Product Improvement: Ball Float Steam Trap G20N

Ball Float Steam Trap G20
Product improvement and model name change

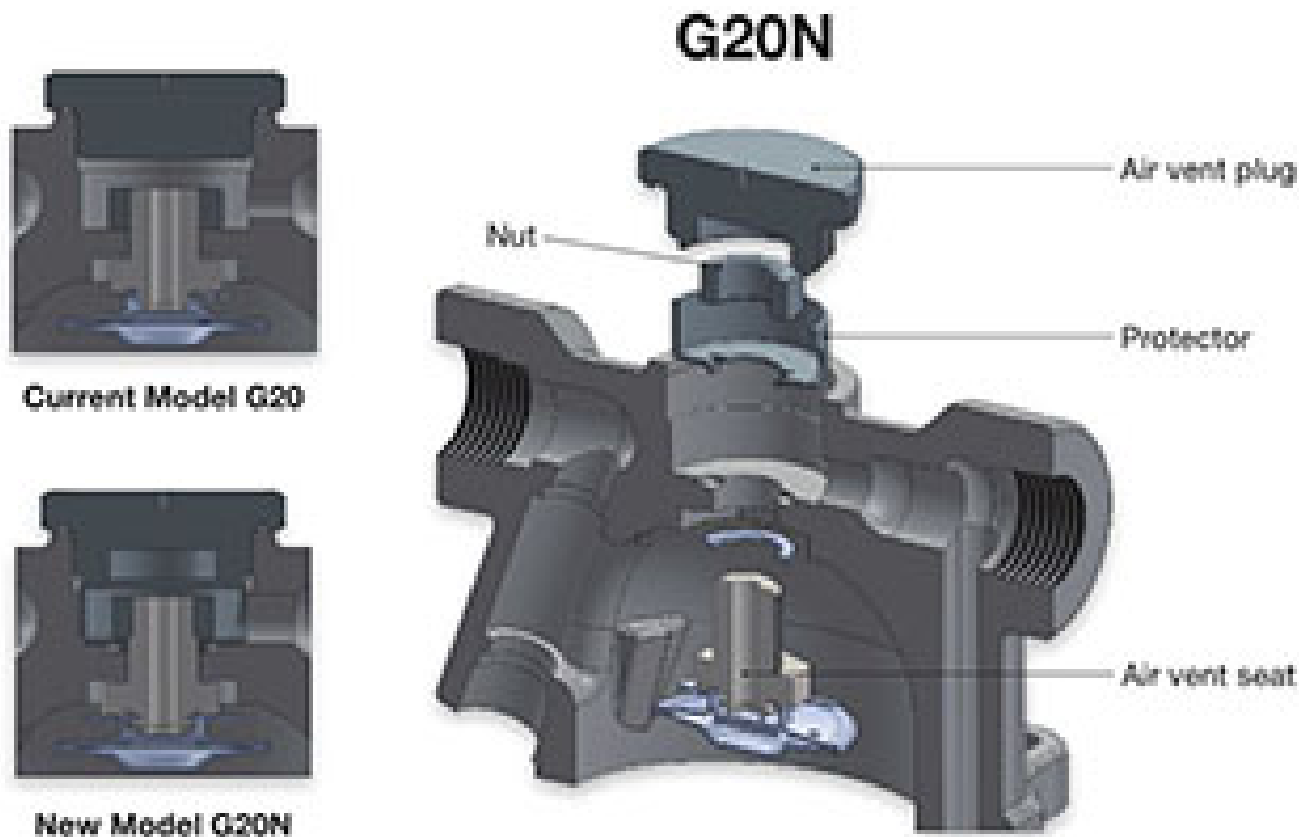
MIYAWAKI would like to announce the following improvements made to the model G20:

1. Addition of a stainless steel protector to the air vent
2. Change of the design of the air vent plug
3. Change of the size of the air vent nut (19 mm k 17 mm)
4. Increase of the length of the air vent seat (+ 2mm)

Due to the improvement the model name will be changed to G20N.
The technical specification of the product has not been changed.
